# **Attachment 1 to Item 2.1.2.**

## **S4.15 Report & Recommended Conditions**

<b>Development Application No.</b>	DA0369/23
<b>Date Received</b>	07/09/2023
<b>Proposal</b>	Demolition of existing residential flat building, construction of new residential flat building comprising three levels, basement car-parking, and associated landscape works
<b>Estimated Cost</b>	\$5,027,000.00
<b>Legal Description</b>	Lot 6 DP 234451 & Lot 7 DP 234451
<b>Property Address</b>	173 March Street RICHMOND NSW 2753
<b>Area</b>	1,176.8m <sup>2</sup>
<b>Zoning</b>	R2 Low Density Residential
<b>Applicant</b>	Mcgregor Westlake Architecture
<b>Owner</b>	Mcgregor Westlake Architecture
<b>Exhibition Dates</b>	10/11/2023 to 24/11/2023
<b>Submissions</b>	Nil
<b>Recommendation</b>	Approval subject to the imposition of conditions.

**Figure 6. Original Elevations submitted as part of DA package.**

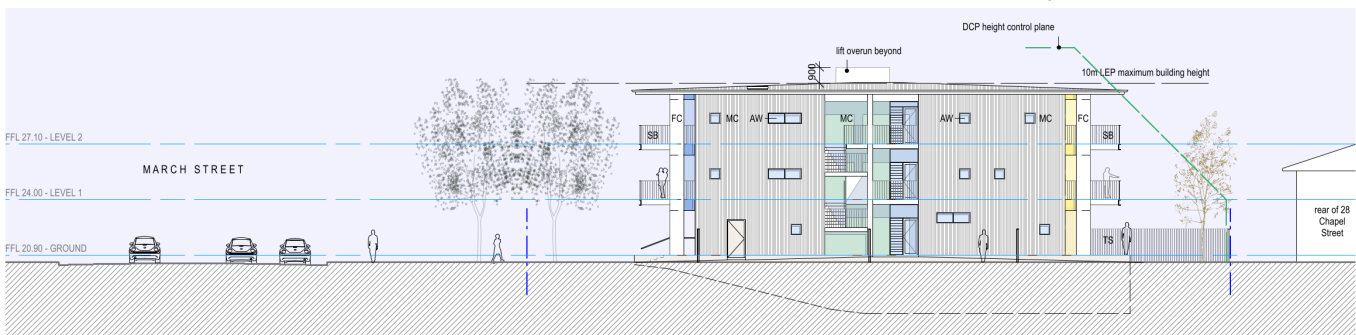
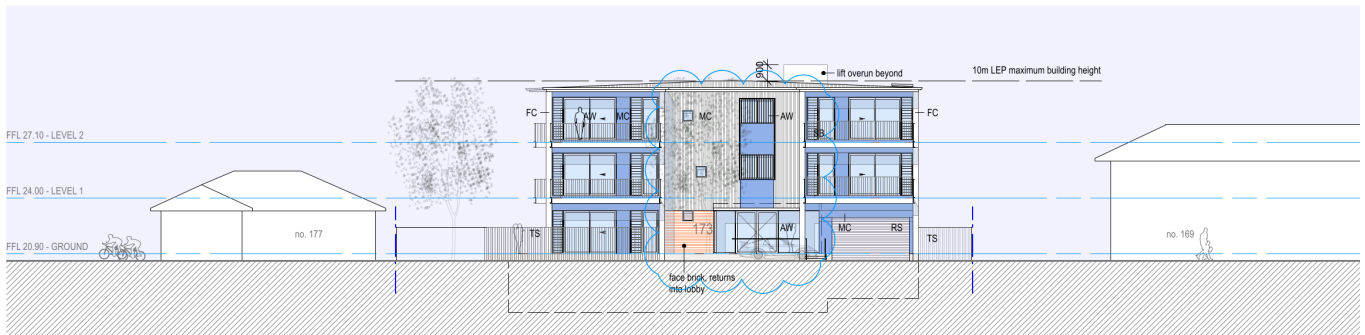
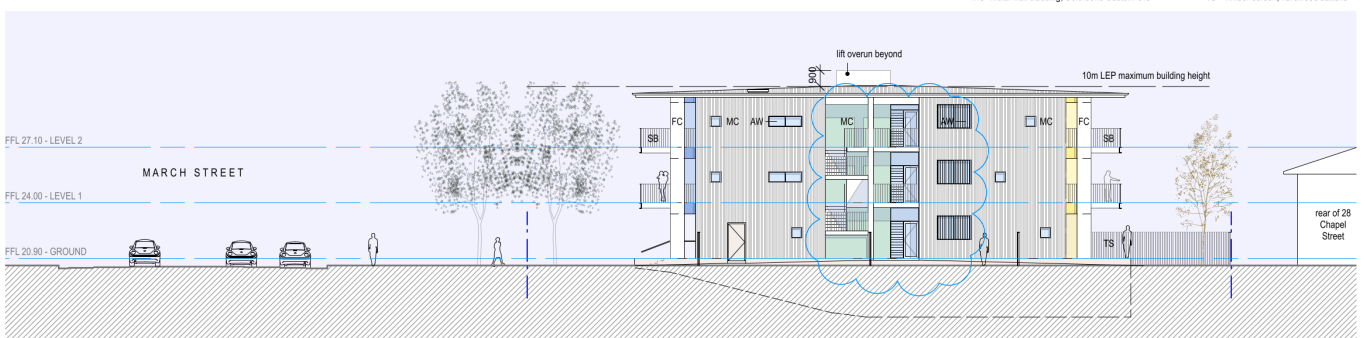
- A combination of metal and coloured metal cladding has now been incorporated into all facades of the development.
- Face brick has been incorporated into the entry wall.
- Bedroom windows added to South elevation.

**Note:** the changes above to the building façade is satisfactory, though it does not significantly enhance the overall aesthetic of the building.

**Figure 9. Amended COS spaces submitted as part of post DRP package.**

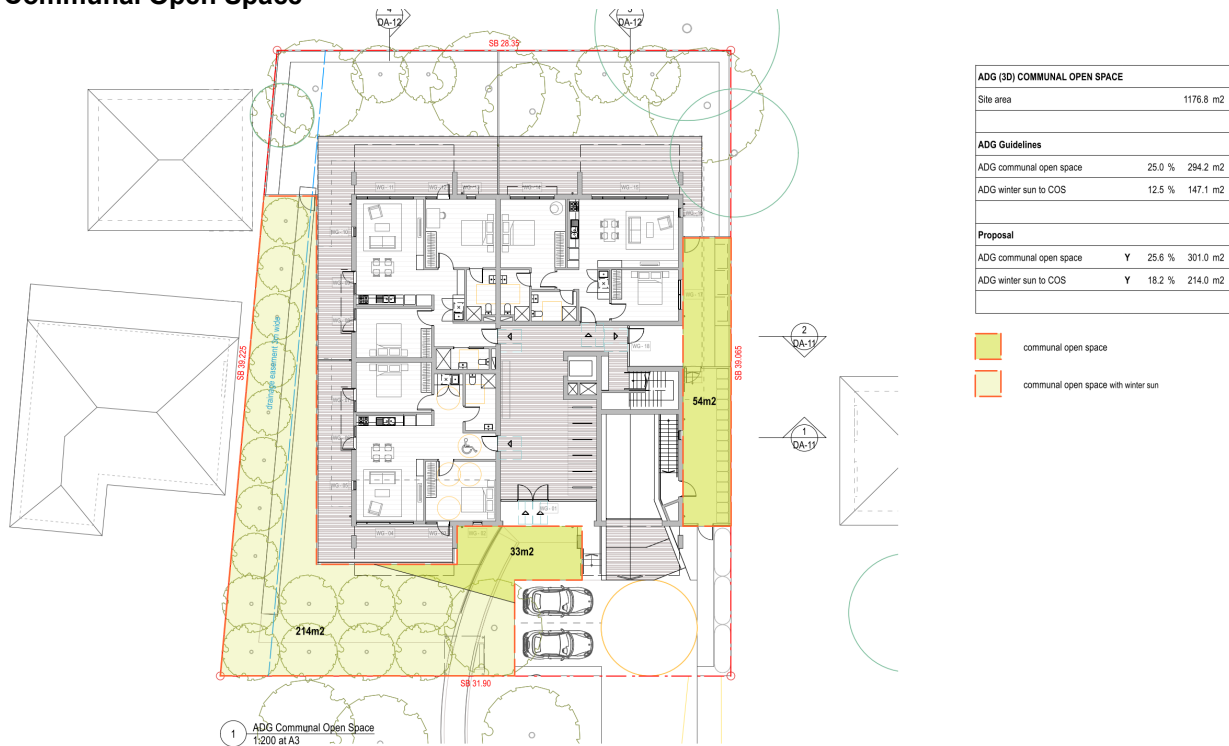
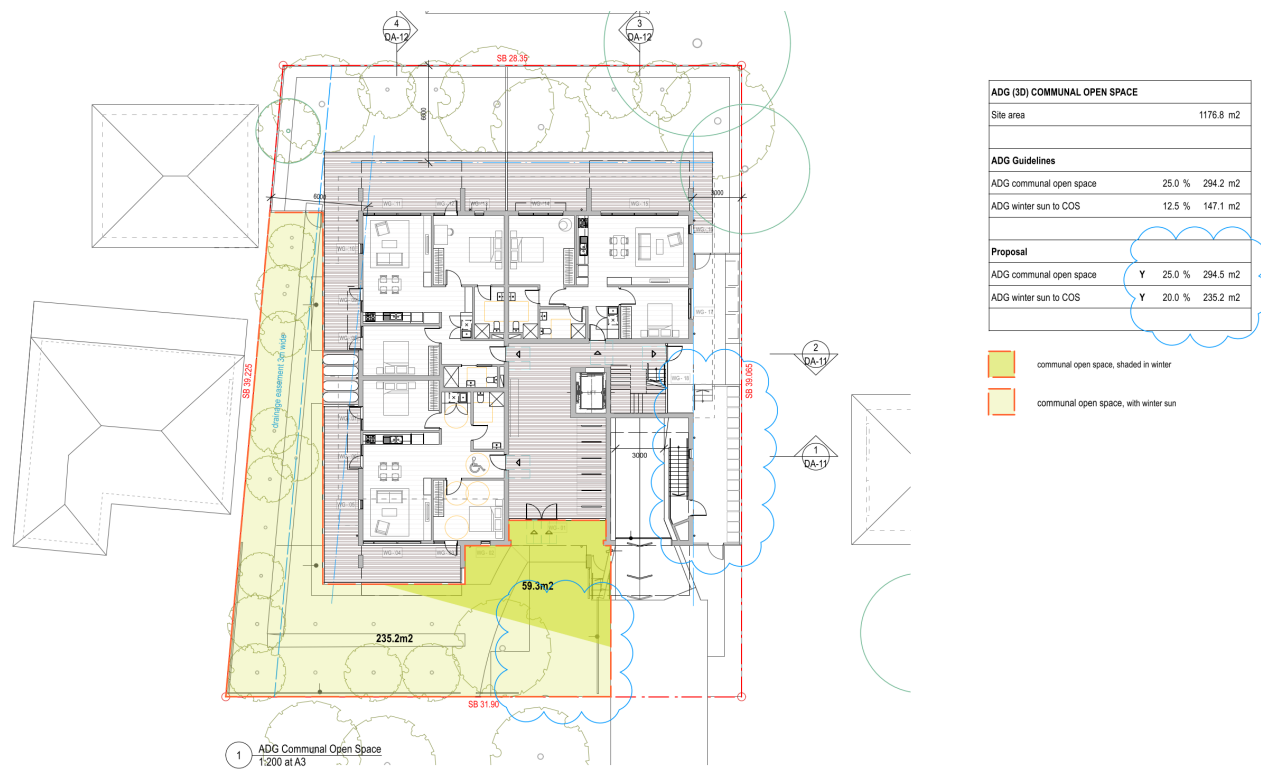
- Consider where an additional communal open space can be allocated to provide a supplementary space for gathering away from the main road and to comply with the total area of communal open space.

- Per figures 8 & 9, the removal of the at-grade visitor parking spaces has allowed for the expansion of the COS to the driveway boundary.
- Removal of waste room and clothes drying area from COS calculations.
